MAS003636 RU 23-25

Rapid Update 636 Maserati Grecale – ICS Blistering

DATE: JUNE 13 2023

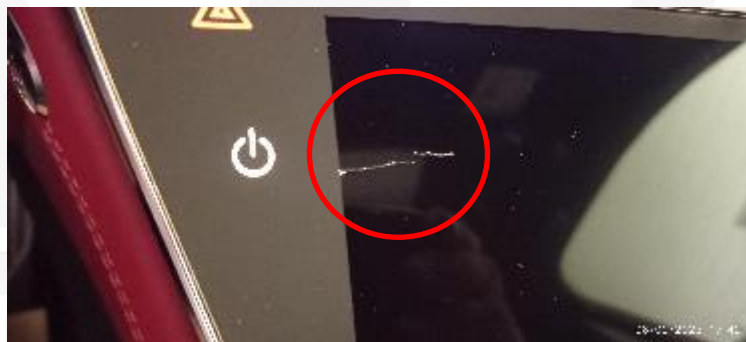
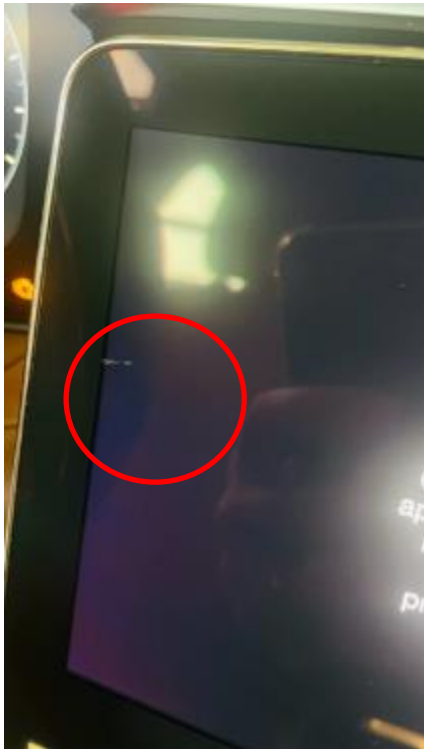
Below are example pictures that show bubbling of the screen. Although the issue may not be present earlier in the vehicle's life, the anomaly can occur later. For this reason, the ICS must be replaced..

1. Always check ModisCS+ to see if the vehicle is involved in this action and if it has not been previously performed.
2. Disconnect the 12V battery by following the procedure in the workshop manual:
 - a. **08.20.001 - BATTERY - Connection-disconnection of power supply**
3. Replace the display following the procedure in the workshop manual:
 - a. **8.71.240 DISPLAY - E208 Integrated central dashboard (ICS) Removal-Refitting or Replacement**
4. Reassemble all removed parts in reverse order following the workshop manual procedures.
5. Carry out all functional test.
6. Procedure complete.
